SITE PLAN REVIEW SHEET ENVIRONMENTAL VARIANCE REQUEST ONLY

CASE: SP-2021-0242C ZONING AND PLATTING COMMISSION DATE: November 15, 2022

PROJECT NAME: Loyola Junction Apartments

The applicant is requesting to vary from LDC 25-8-342 to allow fill over four feet to 17 feet within the desired development zone.

TYPICAL SMALL LIMESTONE BLOCK MSE WALL FILL CONDITION CROSS-SECTION

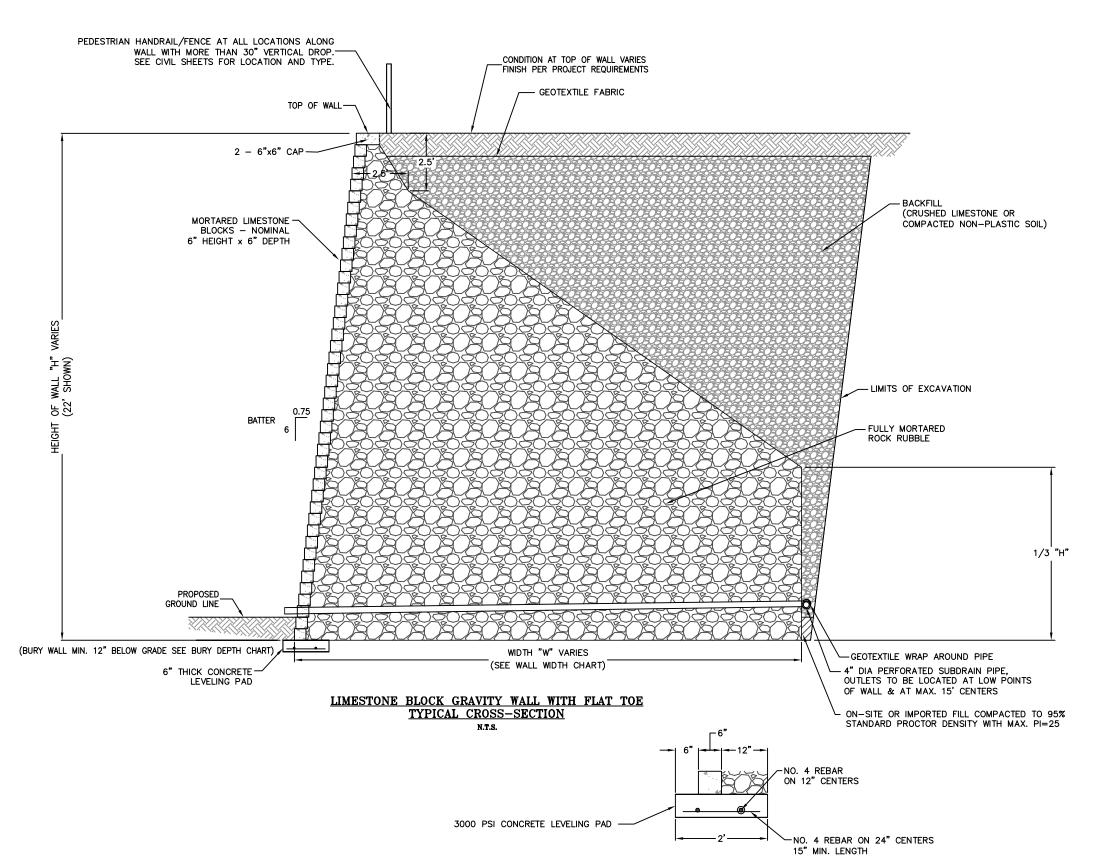
- o Install a retaining wall to contain the major fill areas
- o Utilize terracing techniques in the areas of major fill
- o Increase the CEF setback for the existing CEF wetland feature in the area by 50 feet
- o Add additional COA 609S Native seeding at the bottom of the major fill areas

- Install 355 linear feet of retaining wall to contain the major fill areas
- Utilize terracing techniques in the areas of major fill
- Increase the CEF setback for the existing wetland CEF feature in the area by 50 feet
- Add an additional 7,100 square feet of COA 609S Native seeding at the bottom of the major fill areas

- 1. Added retaining walls (355 lf) to contain the major fill areas.
- 2. Utilized terracing techniques in the area of the major fill areas.
- 3. Increased setback by 50 feet (0.72 acres) for the existing CEF/Wetland feature
- 4. Added additional 7,100 sf of COA 609S Native Seeding at the bottom of the major fill areas.
